**Re: Flatiron Meadows Planning Area C Preliminary Plat, Amendment No. 2  
Comment Response Letter**

**FLATIRON MEADOWS – PLANNING AREA C  
PRELIMINARY PLAT REVIEW RESPONSE**

# FLATIRON MEADOWS PRELIMINARY PLAT, AMENDMENT NO. 2

Sheet	3
<b>PH1</b>	of 13
Date	JANUARY 27, 2017

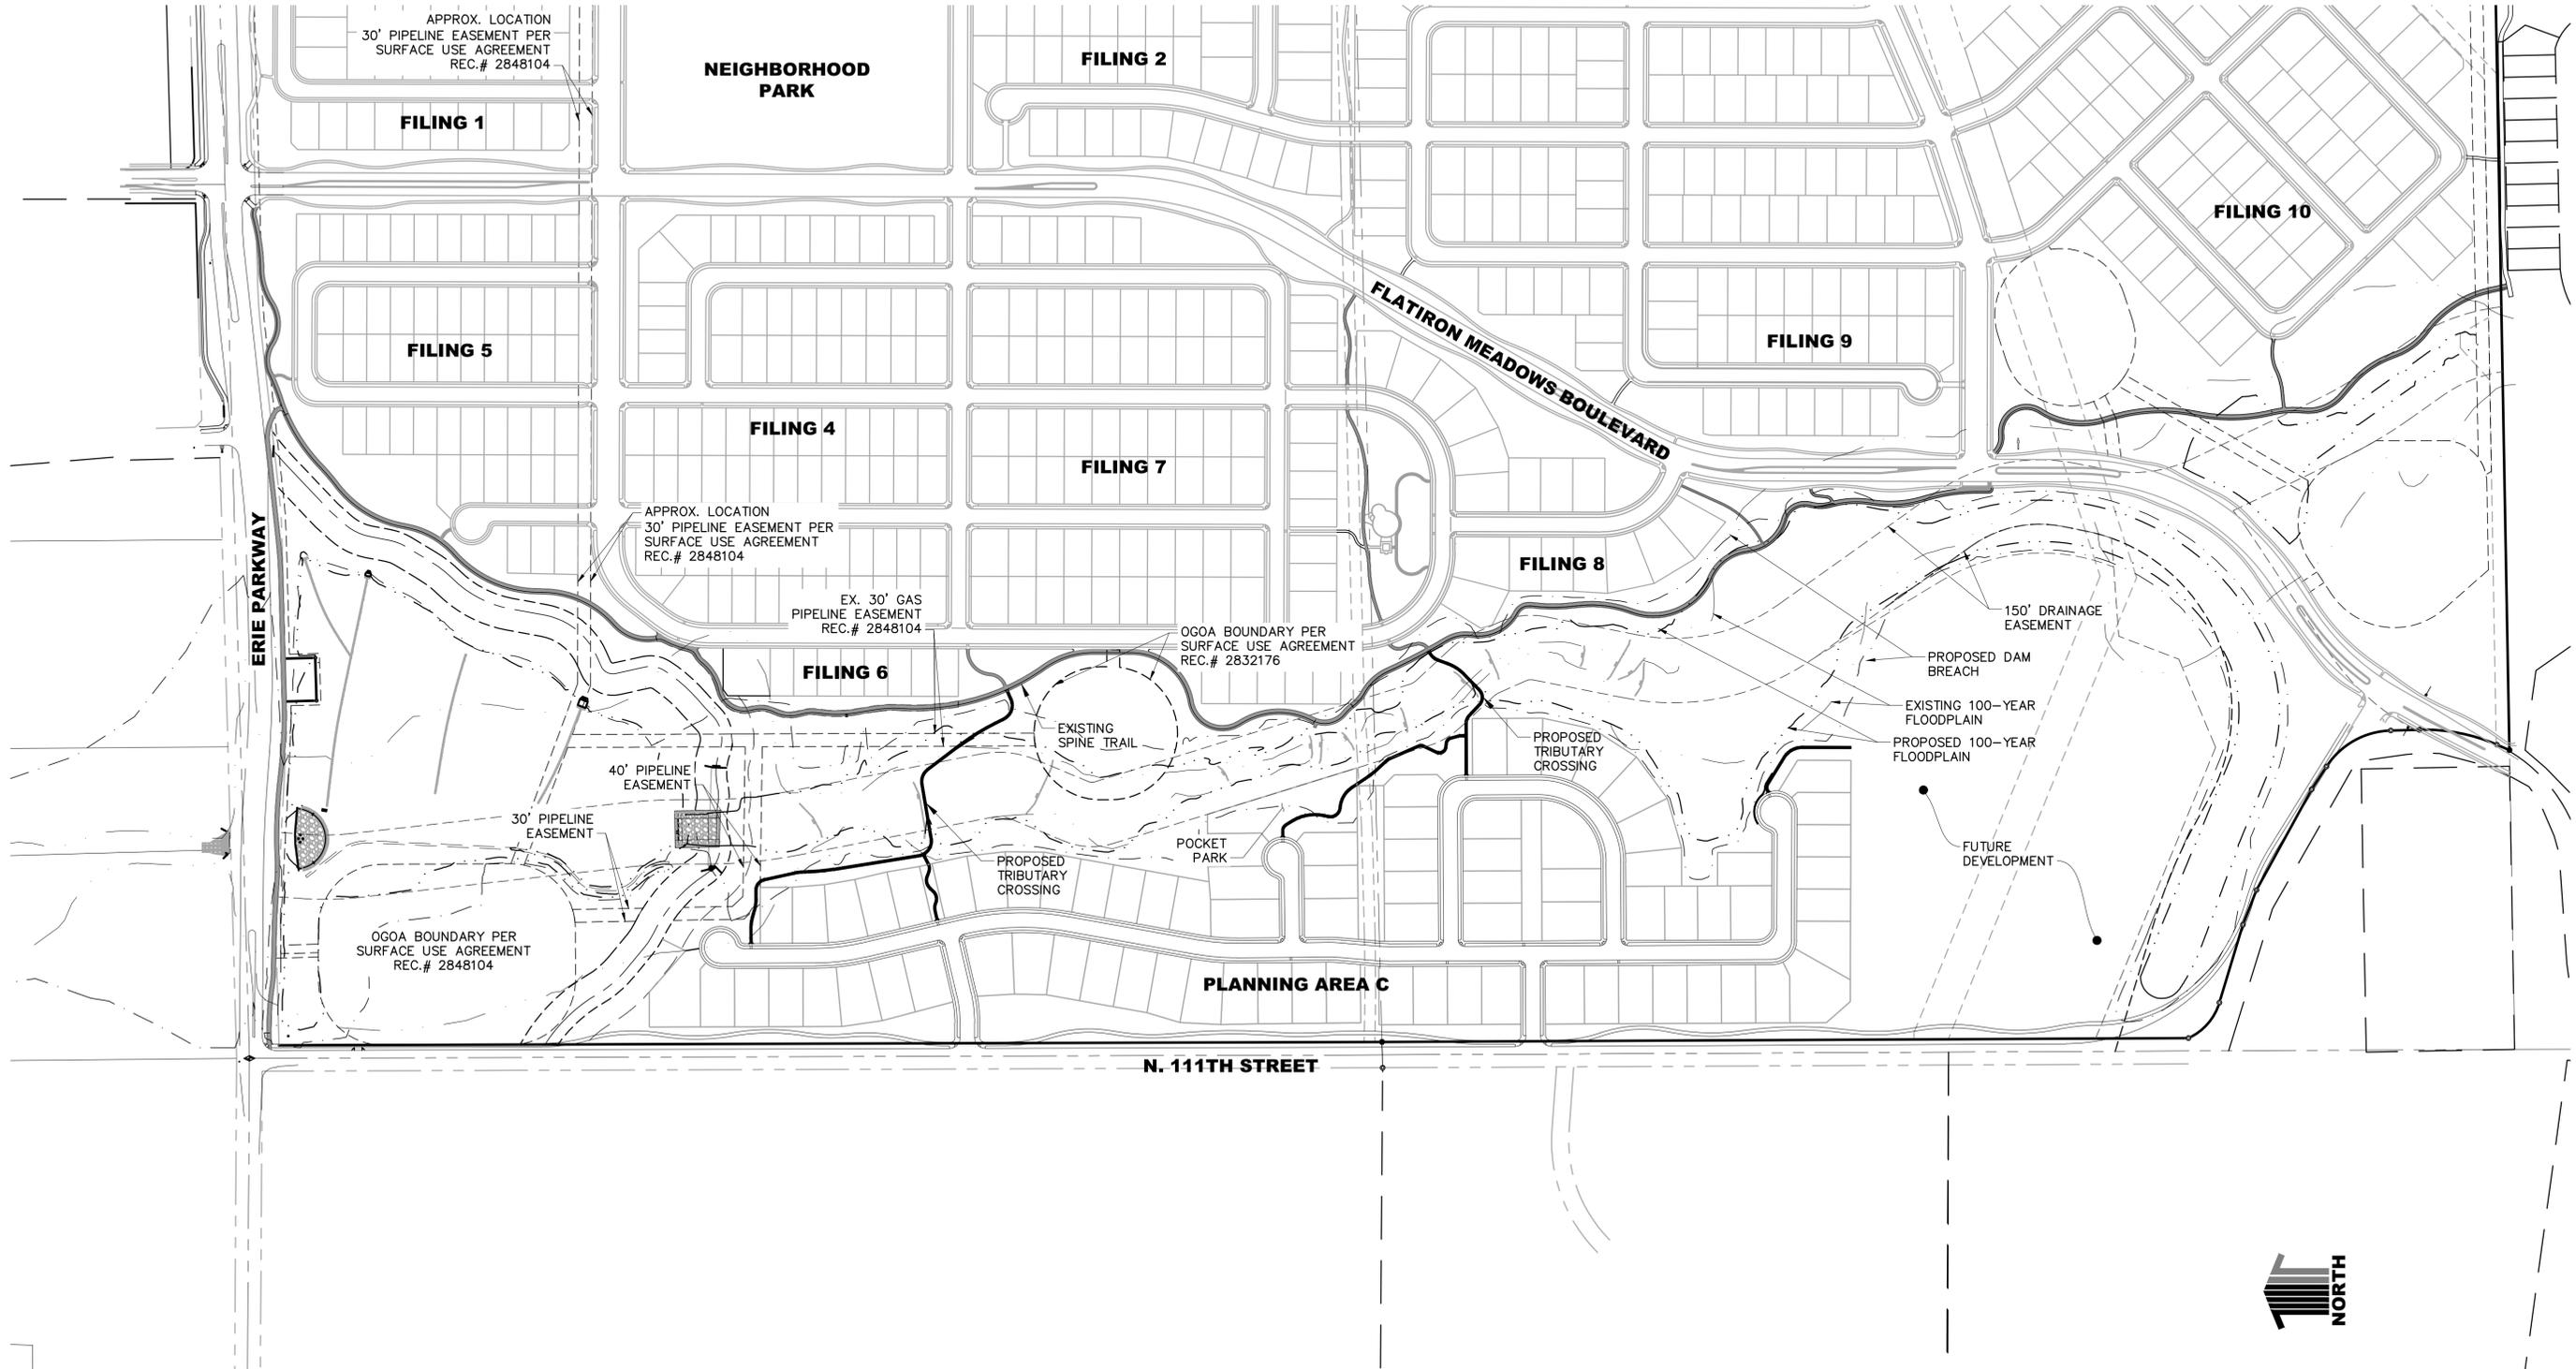
4. Sheet PH1 – Phasing Plan
  - a. Some lots are missing number labels. Please add.  
*Response: This has been corrected.*
5. Sheet TR1 – Trail Plan
  - a. Trails are not shown at all through-block connections and ends of all cul-de-sacs. Some connections may be limited by grading restraints. While a trail along the back sides of lots west of the tributary may not be feasible, some rear of lot connections can be made. See redlines and add connections.  
*Response: Requested trail connections have been added.*

Sheet	5
<b>TR1</b>	of 13
Date	JANUARY 27, 2017

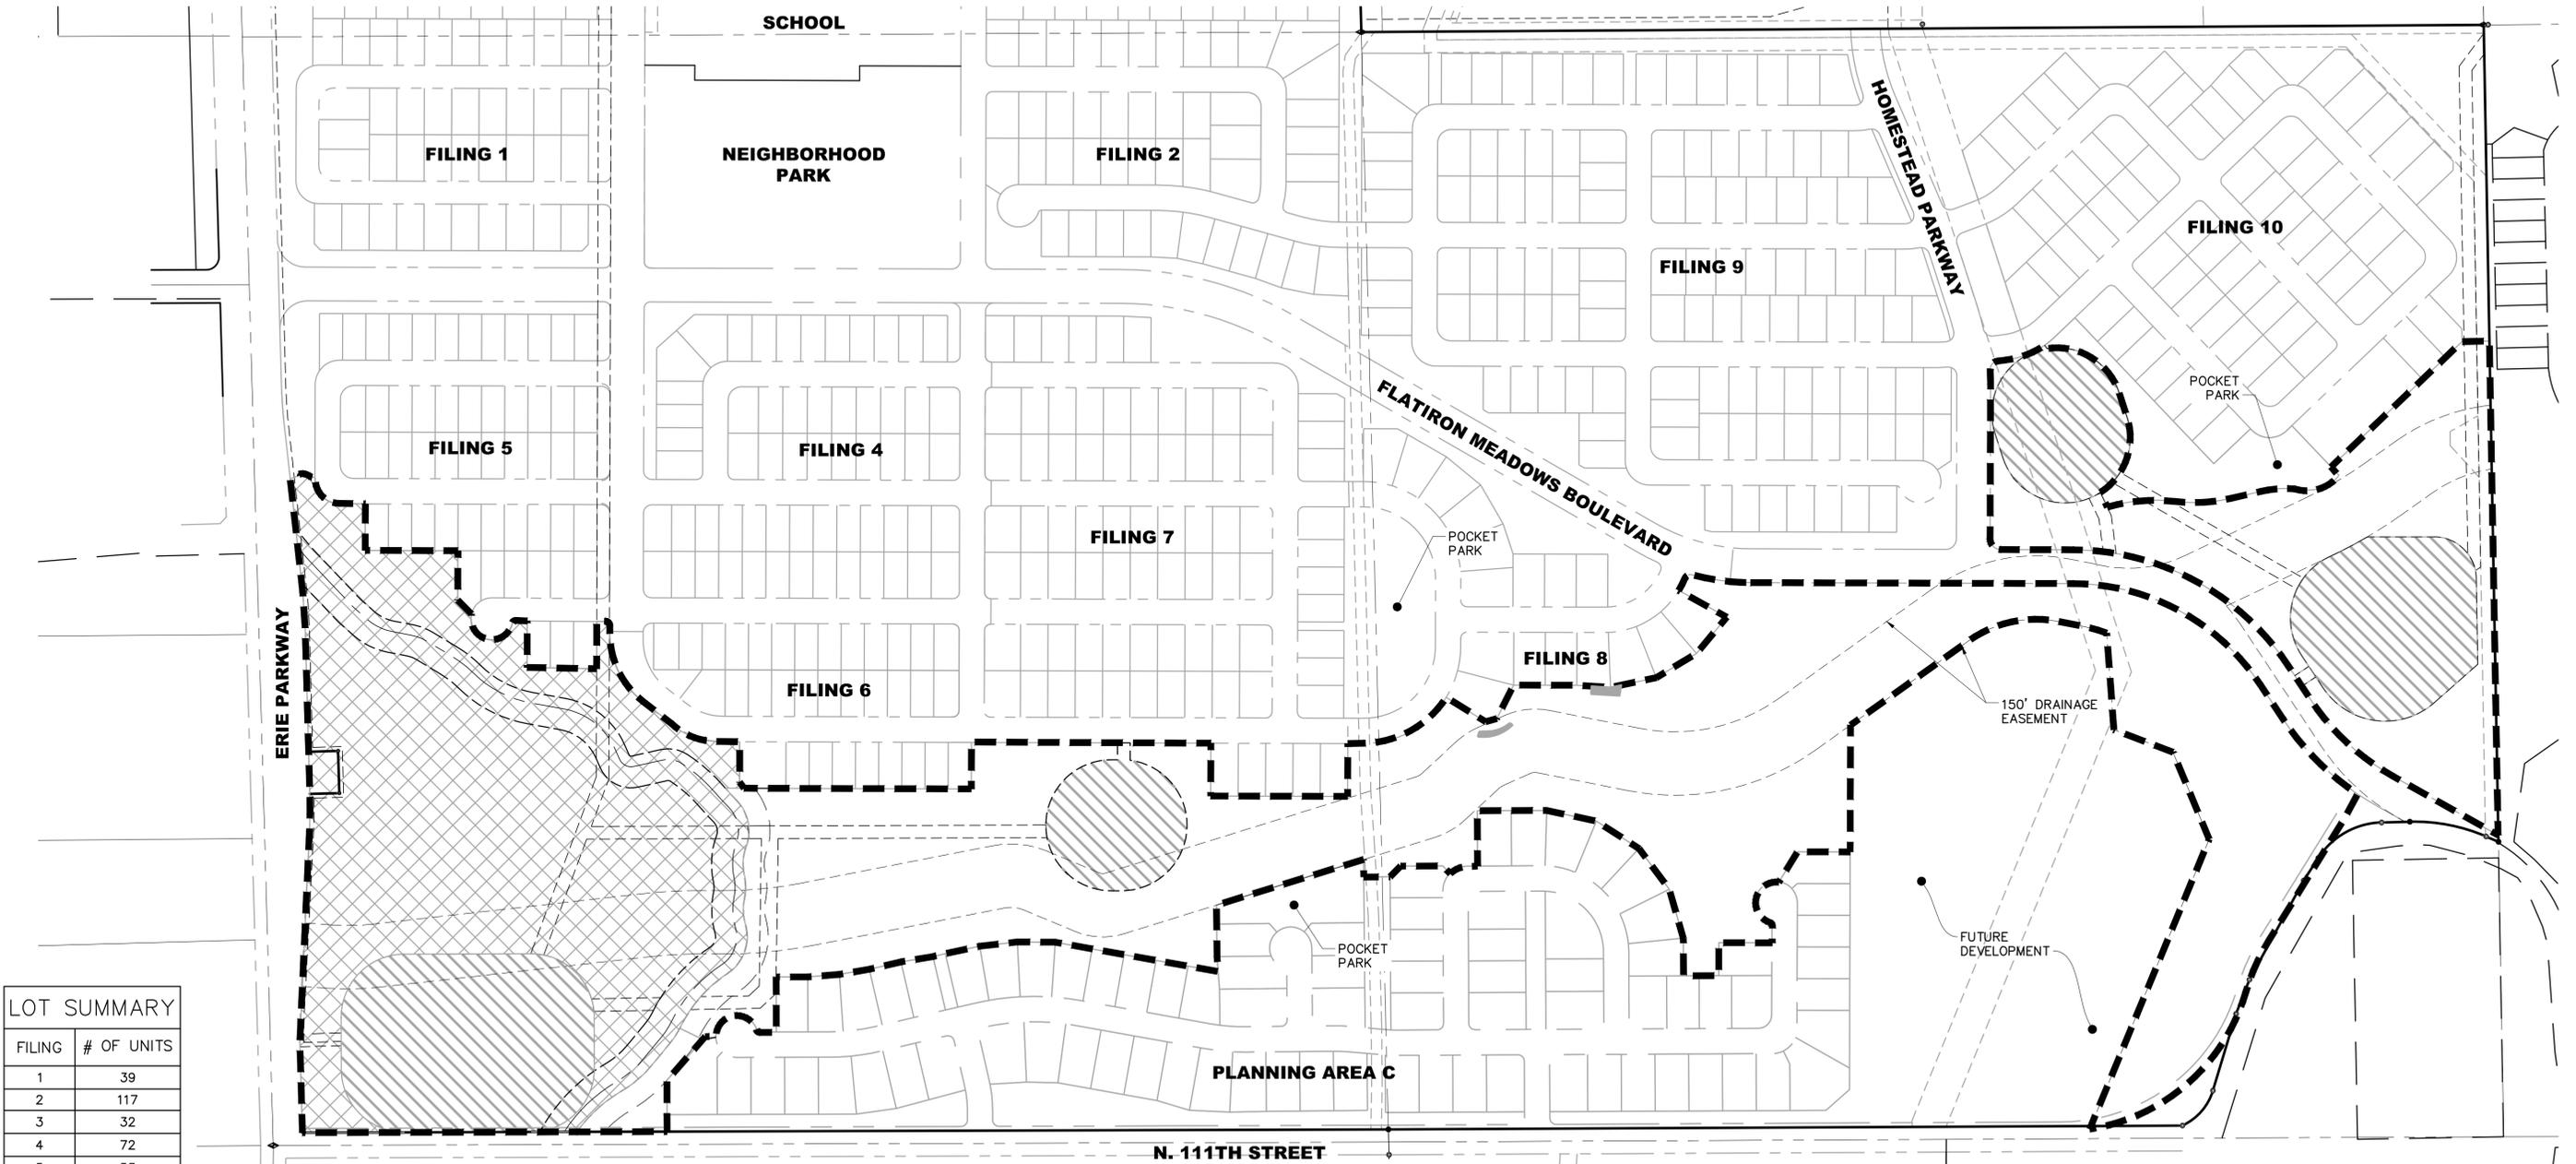
- b. Move the north tributary crossing further to the north. This will limit the amount of time that local trail users are on the regional spine trail.  
*Response: This tributary crossing hasn't been moved north due to safety concerns with a crossing at the drop structure. The crossing to the south is coordinated with the grade control structure and aligned with the sidewalk on the south side of Front Range Lane.*

- c. Move the tributary crossing at the Pocket Park further to the north to align with the Pocket Park in Filing 8 and to limit the time people using local trails are on the Spine Trail.  
*Response: The tributary crossing has been moved to align with the grade control structure and aligned with the Filing 8 local trail.*

2. TR1: Crosswalks are recommended where Roads 2 and 4 intersect with N. 111th St.  
*Response: Acknowledged. A signage and striping plan will be submitted with the final plat.*

3. TR1: Show trail and tributary crossing connecting pocket park and spine trail per the layout shown on L.10.  
*Response: Trail connections and tributary crossings have been added to the plan per Town comments. The trail from the Pocket Park will cross the tributary further south and connect to the Spine trail by Filing 8.*

**FLATIRON MEADOWS**  
 PRELIMINARY PLAT  
**OPEN SPACE PLAN**

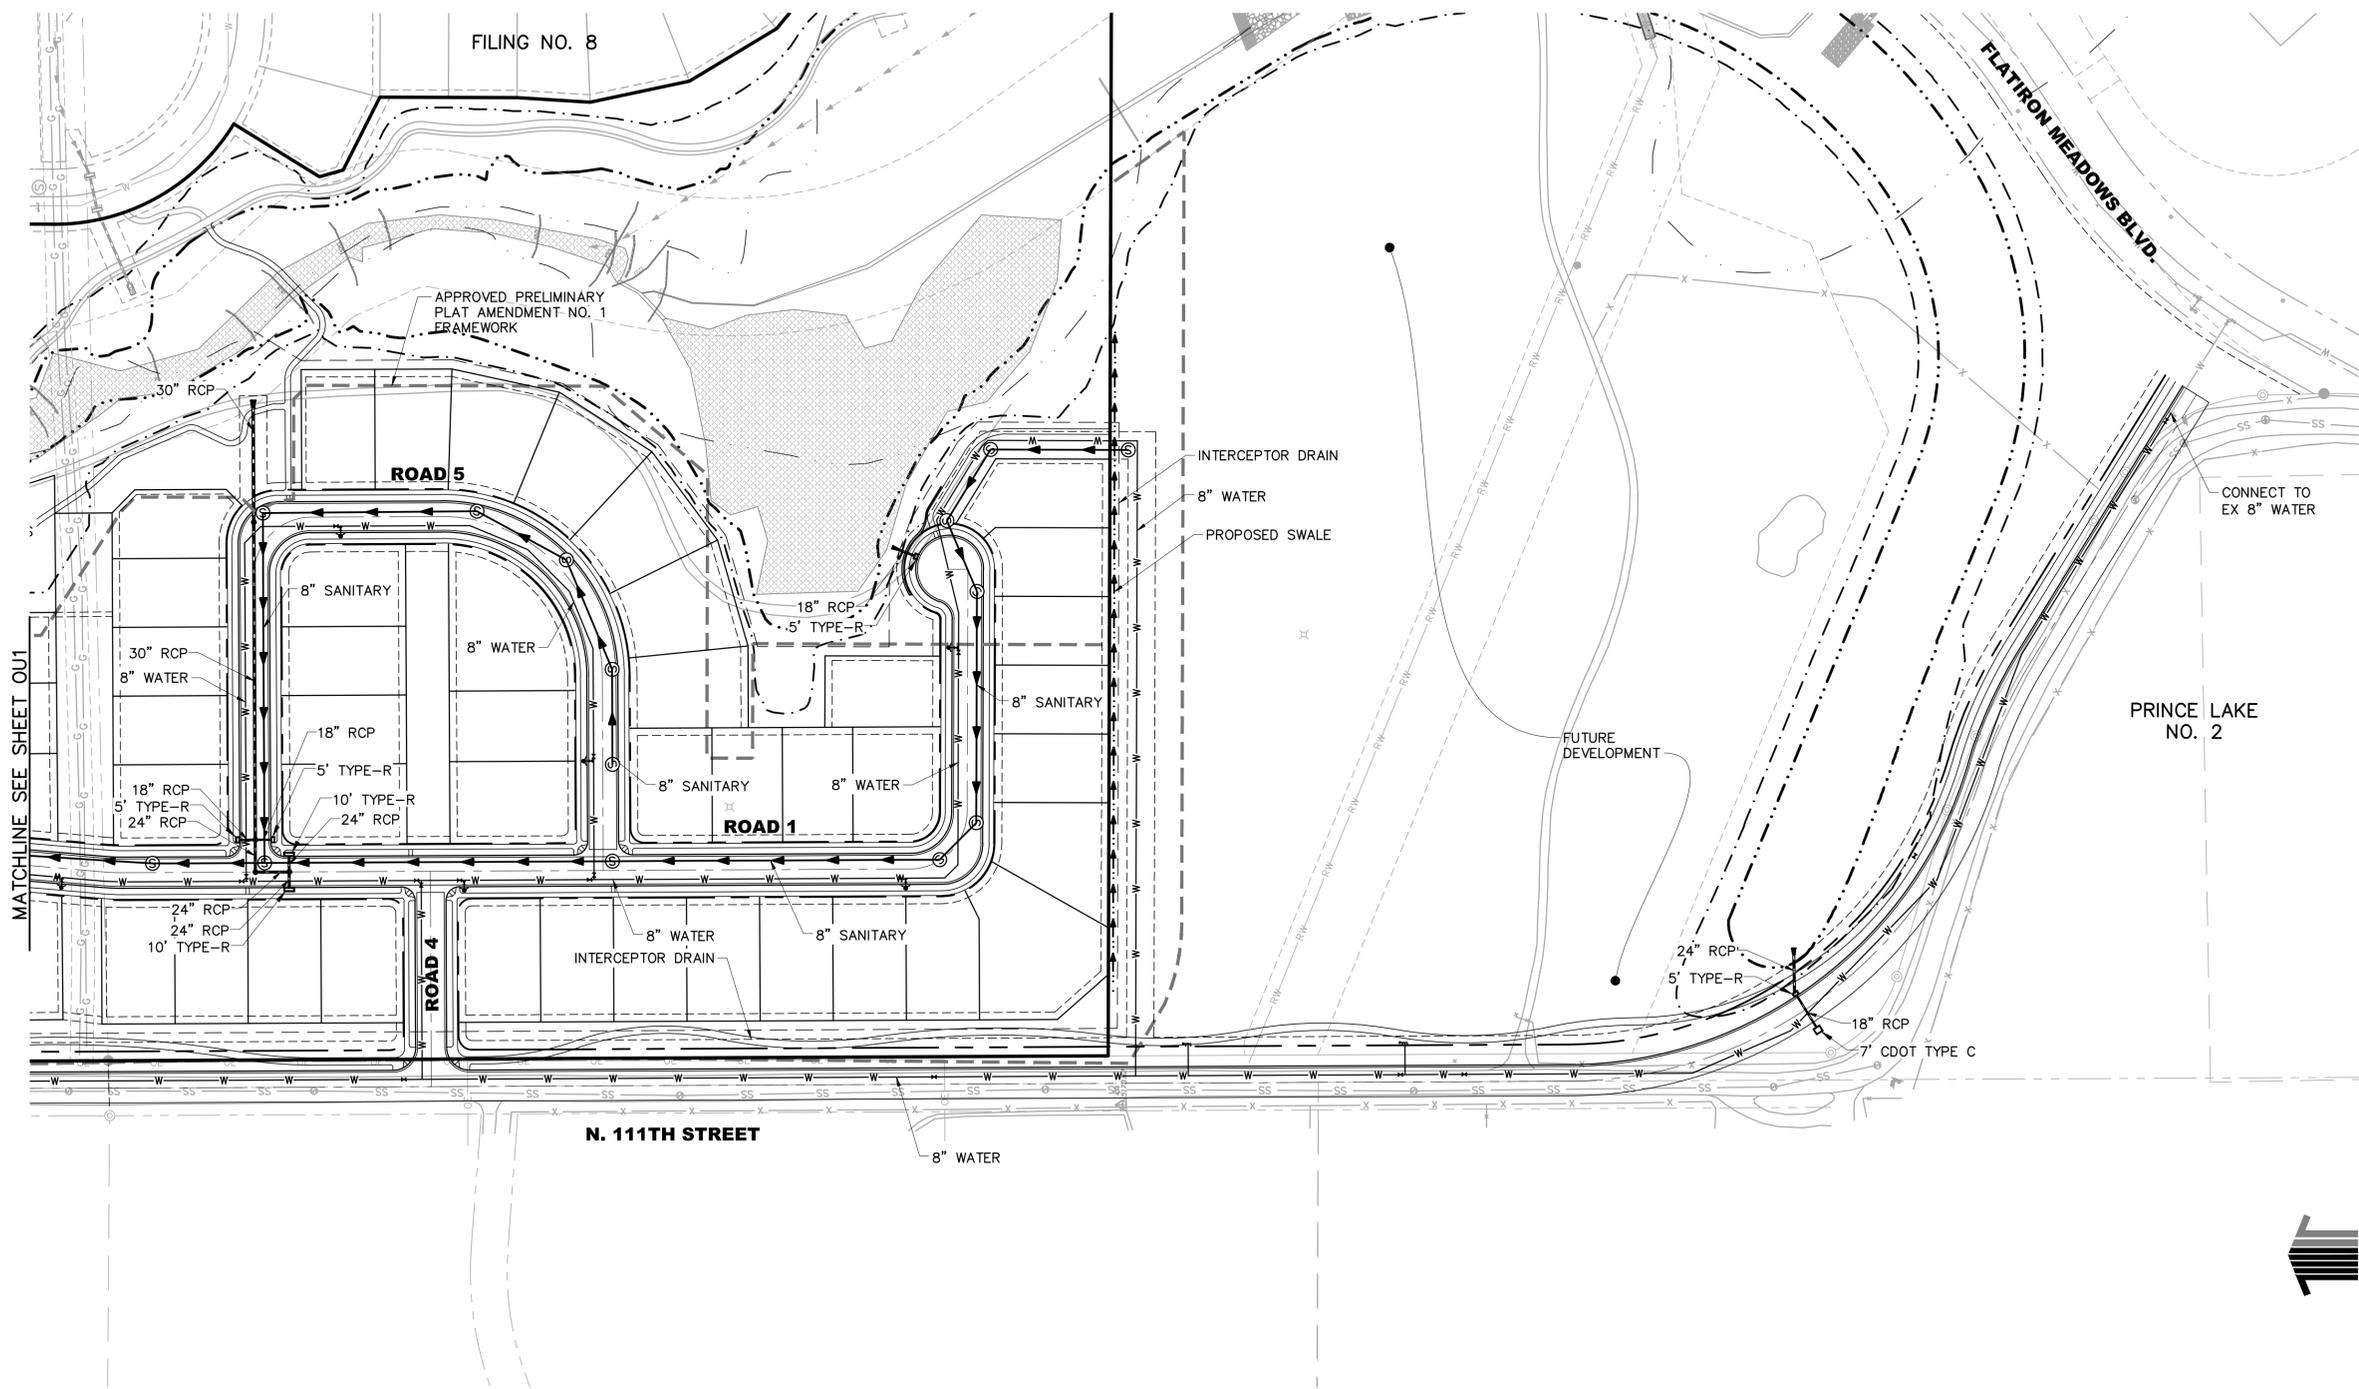
Discussion: A new sheet, Open Space Plan (sheet 6 of 13), provides the information that we previously requested; "Identify the tracts throughout the entire development that will meet all the requirements in the UDC for dedicated open space. At a minimum, provide the required acreage, and the total acreage and qualified acreage in each tract". This sheet shows the dedicated open space in this application, Filing 10, and a future filing that will be immediately south of this application. After subtracting acreage that does not meet the requirements in the Town's Unified Development Code (UDC), the qualifying open space is 44.62, above the required 38.61 acres. We thank you for providing this information in an easily understood format.
